Appendix A
Documents provided by the Stakeholder
Groups during the consultation process

Doc. No. P0027301-1-H3 Rev. 0 - September 2022

ALBERT COLLEGE RESIDENTS ASSOCIATION METROLINK SUBMISSION

150 metre station box at the Albert College Park.

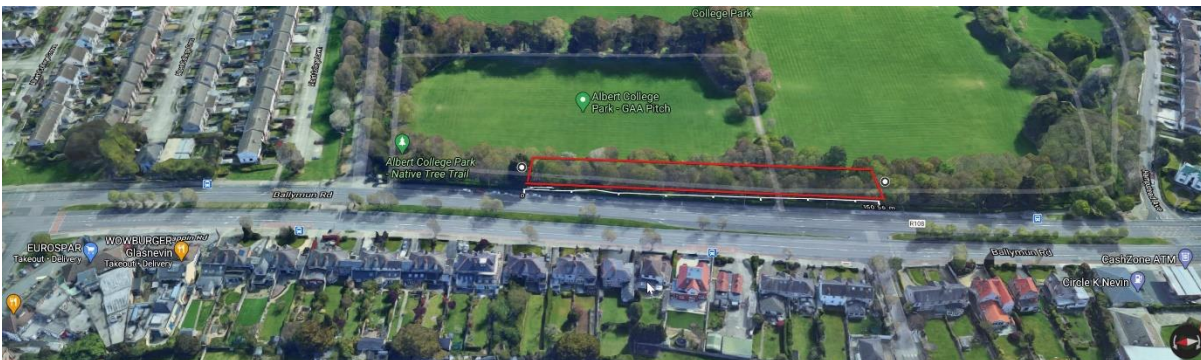
We feel the Albert College Park station location is the best solution for our locality.

It is far from the Schools to avoid the issues with parent & child access.

The Church is not surrounded by a construction site with limited access.

Albert College Estate residents do not lose their access onto Ballymun Road.

Albert College Court residents will not have to be rehoused during construction.

Hampstead Residents will not have a ventilation shaft on their door steps.

The park land take is reduced.

It is no longer required to have a ventilation shaft in the park.

A dual entrance station will give greater service to both DCU at the north and the residents south of Albert College Park.

Figure 2 - Intervention Shaft Location Detail

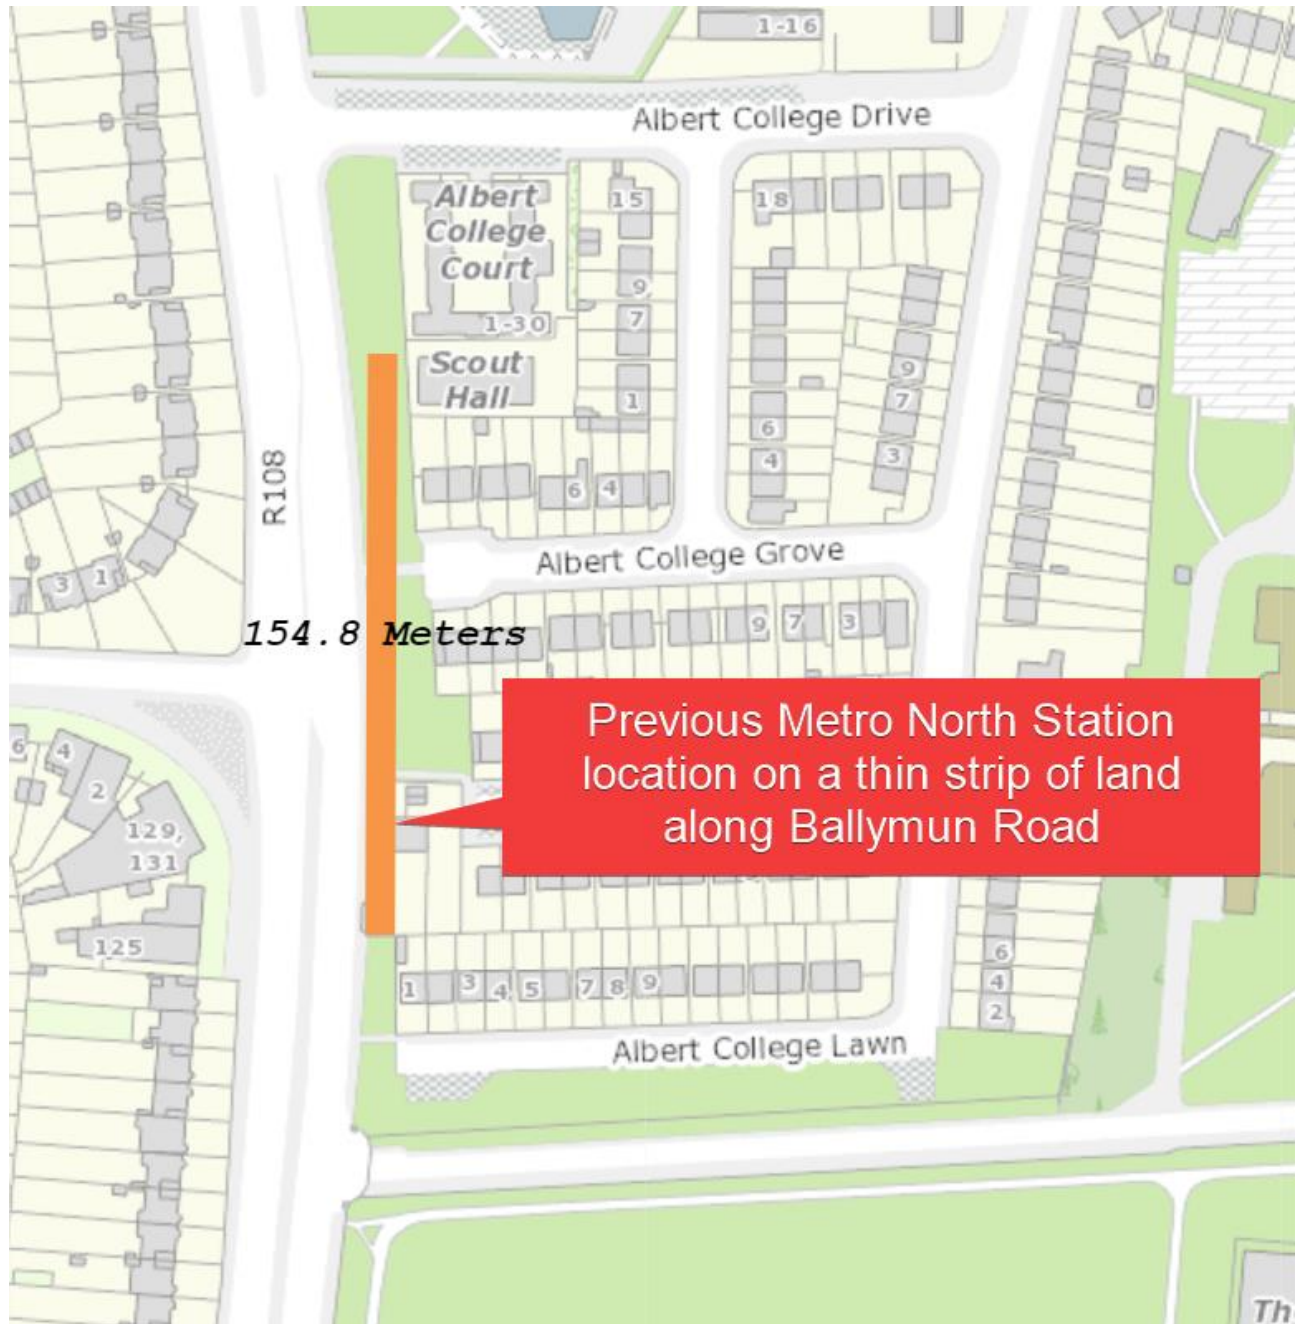
The below image is from Jacob Idom's report on the Intervention shaft (page 11) showing the need for a shaft because of the 1 km best practice distance between stations.

The Park Station suggested above meets the criteria of the 1km distance between the Park Station location and the next station at Griffith Park.

Figure 1.

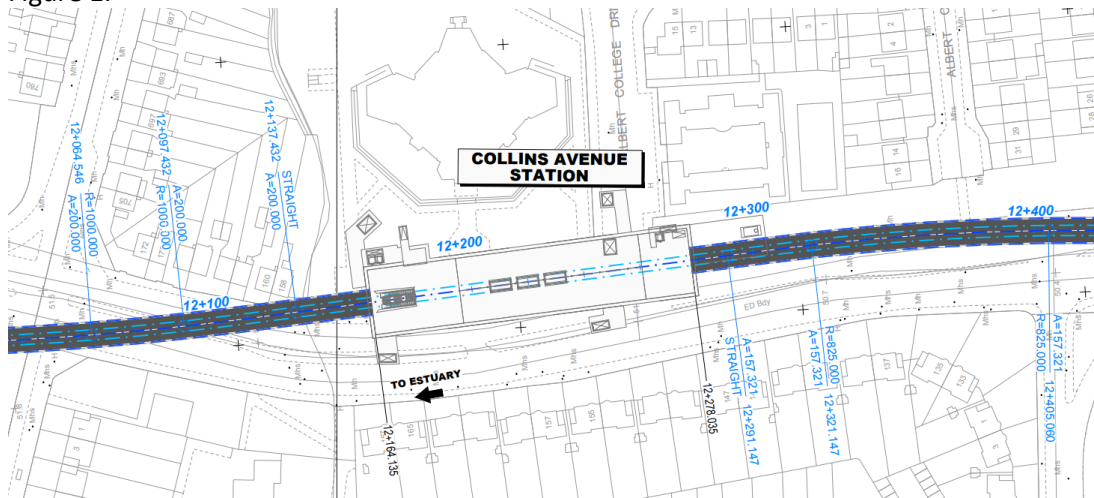
TII's current proposed Church location at 12+164 is 125 metres south of Collins Ave (2 minute walk) and 360 metres north of the DCU main gate. Figure 1.

Figure 2. Our proposed Park Station location.

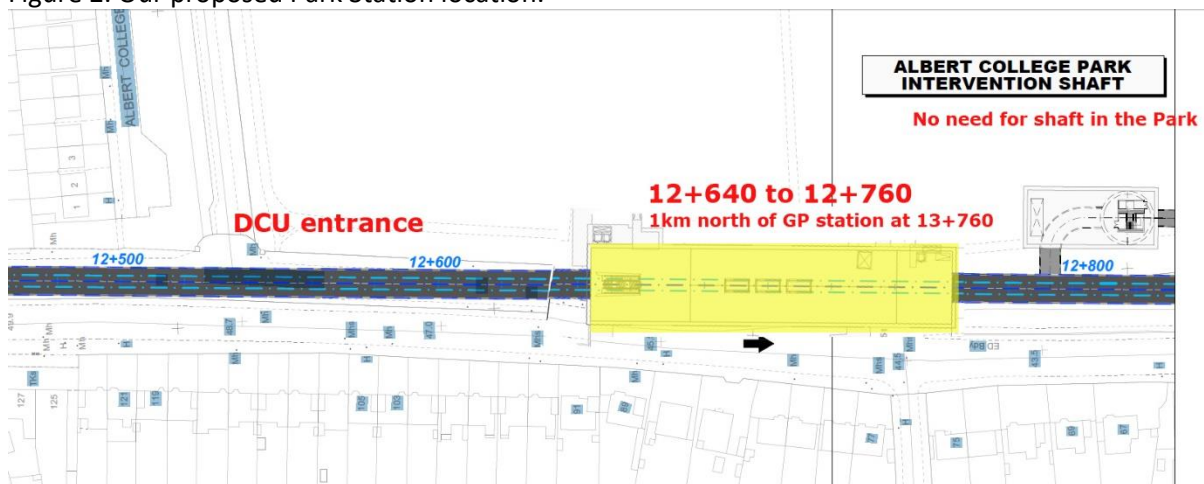
Whilst our proposed Park Station Figure 2 below would be a further 400 metres (5minute walk) south of the current Church station location we would question the premise that an extra 5 minute walk would reduce footfall to such a degree given the vast majority of users of the station would be from DCU and the future housing developments located nearby.

(Pic . 1)

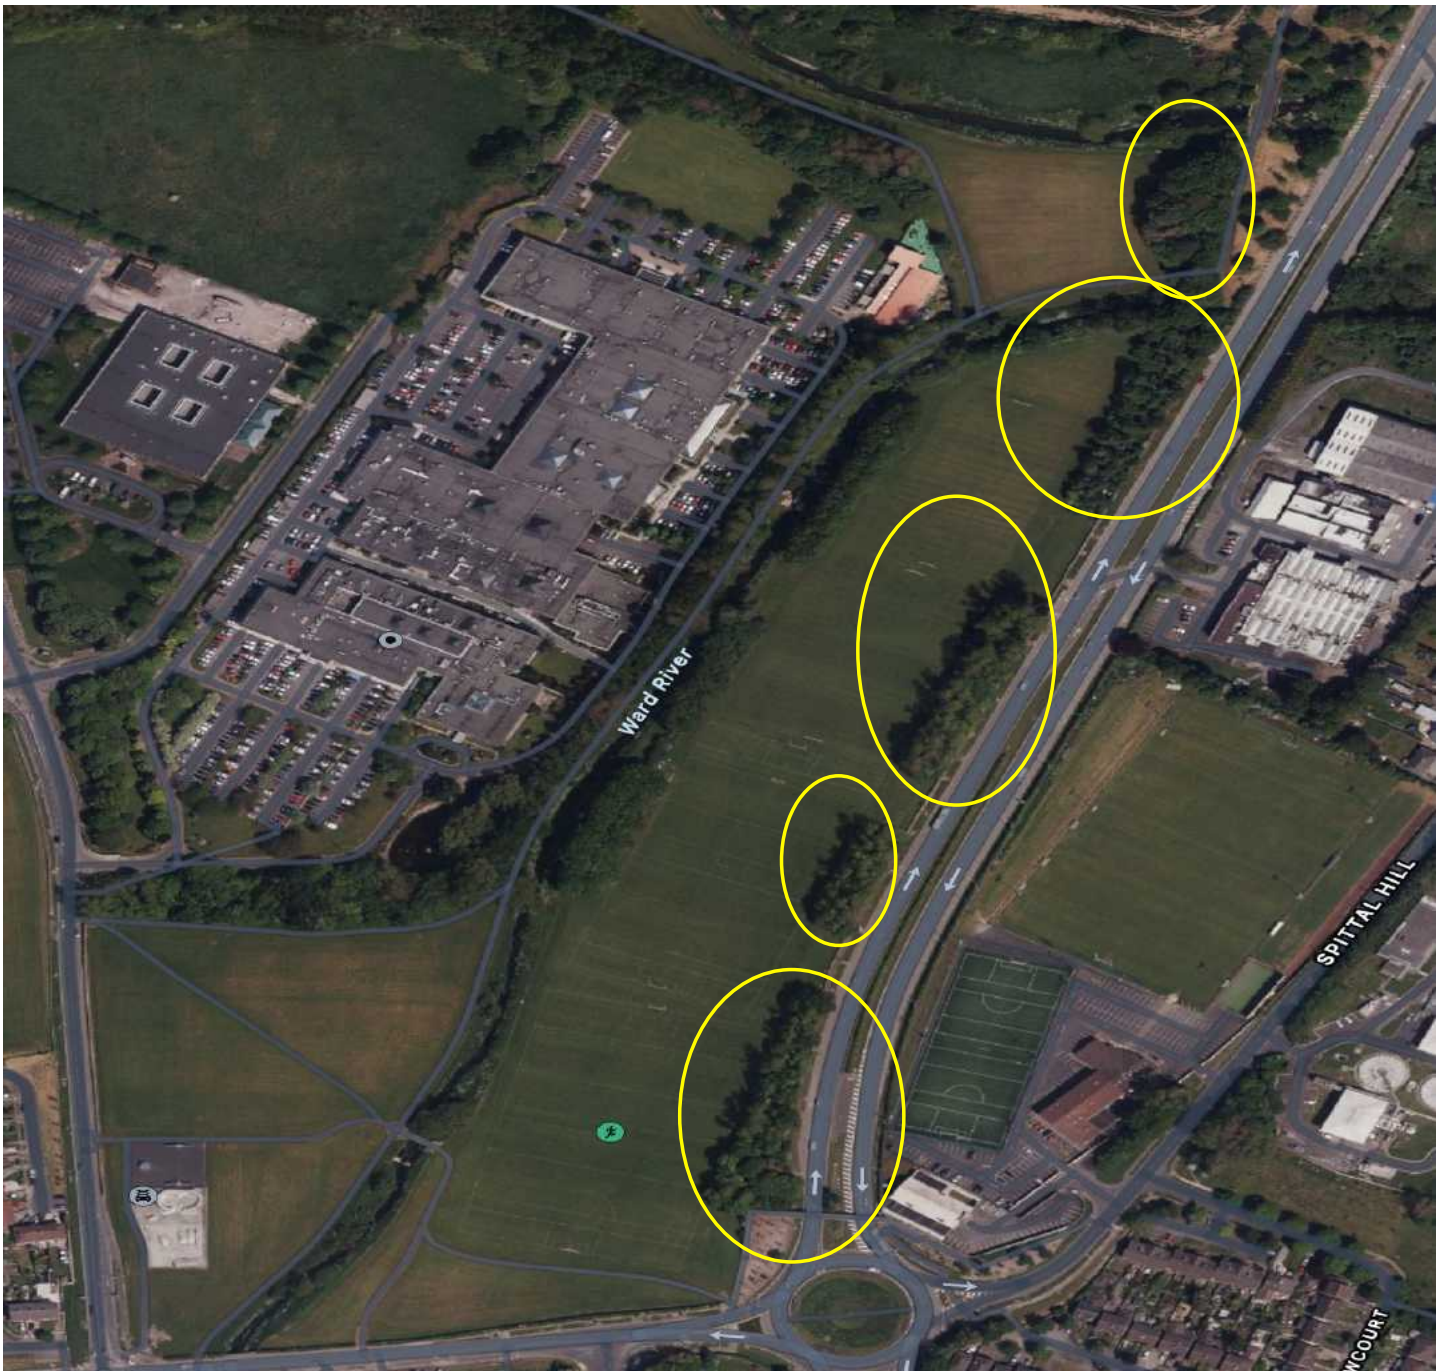
To remove these pitches would have a detrimental effect on the community in terms of both environmental (as per above) and community and would in my opinion be against the “ General Settlement Objective “ namely :

“Retain existing tree-lined approaches to all towns and villages to preserve their special character”

National Museum Archives /Former Motorola Plant . Pic 3

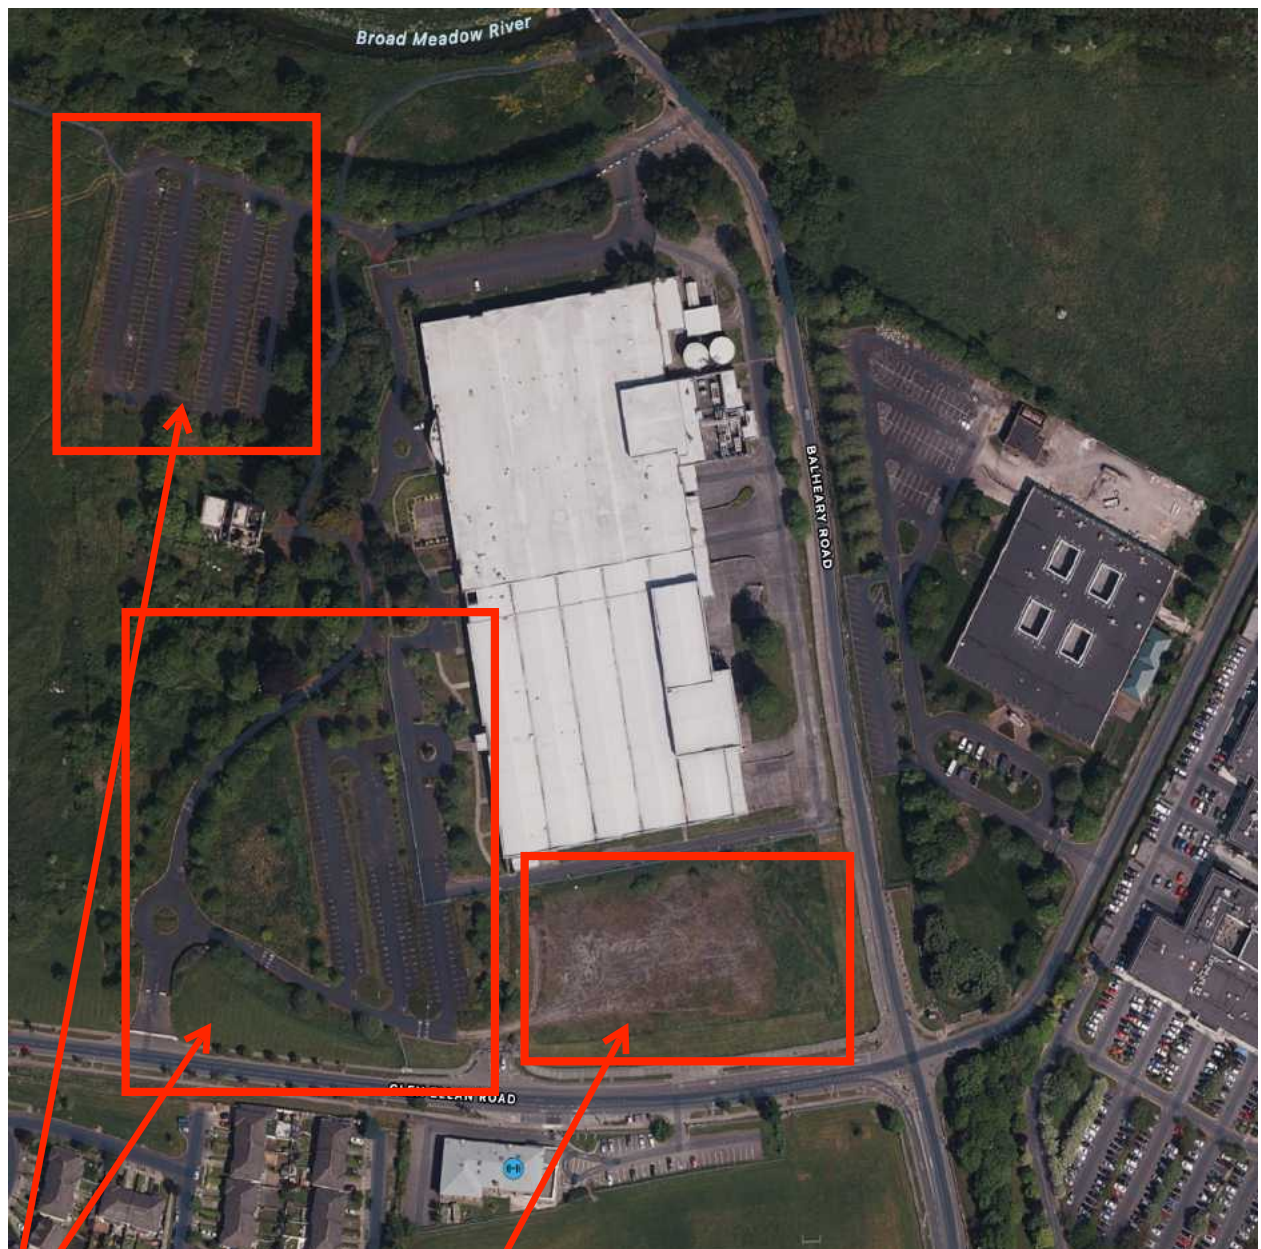
Option 1 – the old Motorola plant / National Museum Archive (Pic 3) which already has a substantial Carpark although overrun with Grass and weeds etc , the infrastructure (hardcore , lighting

ducts , lighting etc) are already in place , it would take far less public money to return this carpark to operation , and is only 200 metres away from our green areas / football pitches.

Old Farm North of Swords Proposed Carpark /Metro Terminus . Pic 4

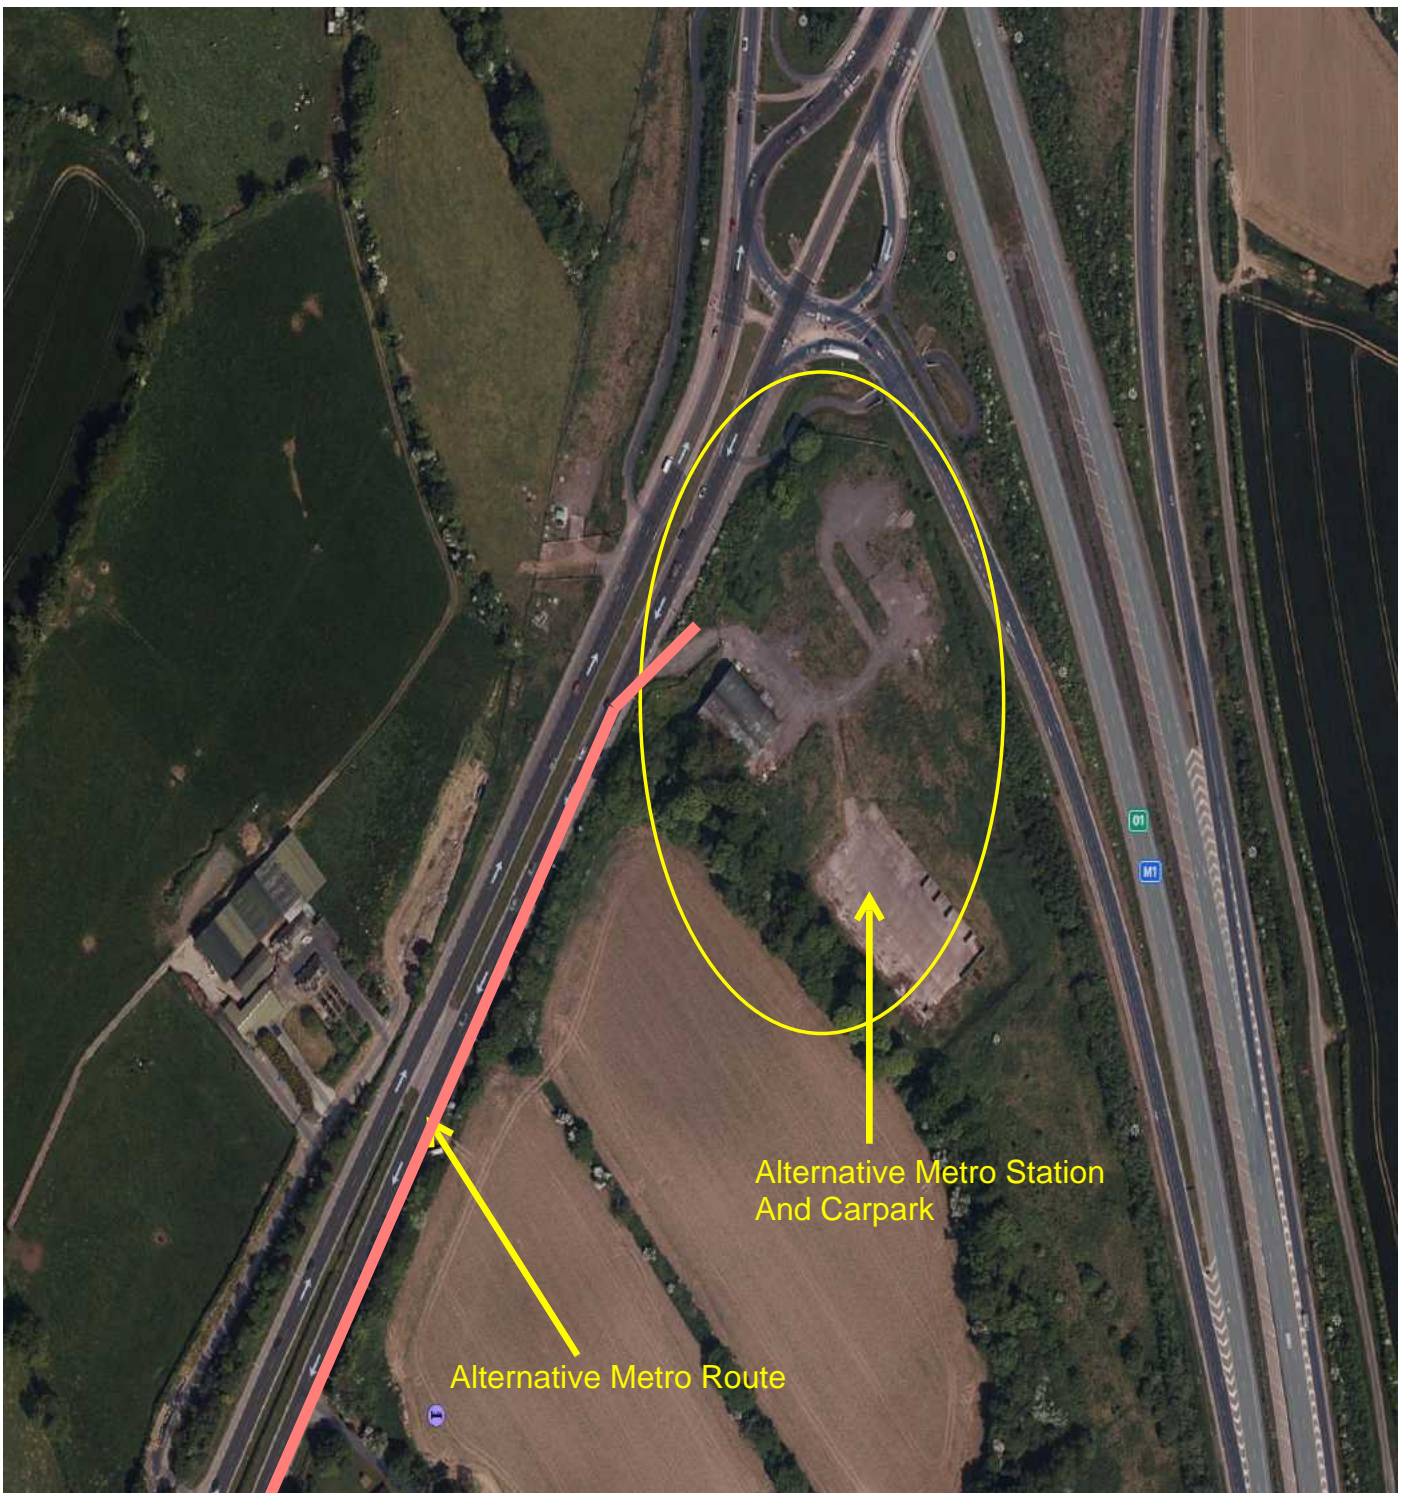
Option 2- The Old farm situated to the North of Swords , that I believe was originally bought by the State for the original Metro North Route which runs parallel with the M1 turnoff (Northbound)for Donabate /Lusk) (**Pic 4**)

This location is ideally situated in that by moving the Carpark and Metro terminus (as shown below) we would be minimising excess traffic into Swords therefore cutting down on congestion and pollution into the greater Swords area .

We would then be able to use either the median strip or reduce the Dual Carriageway to one lane (either inbound or outbound from Swords) for the Metro North track as all the traffic from outlying areas travelling into Dublin City will be parking almost immediately after coming off the M1 .
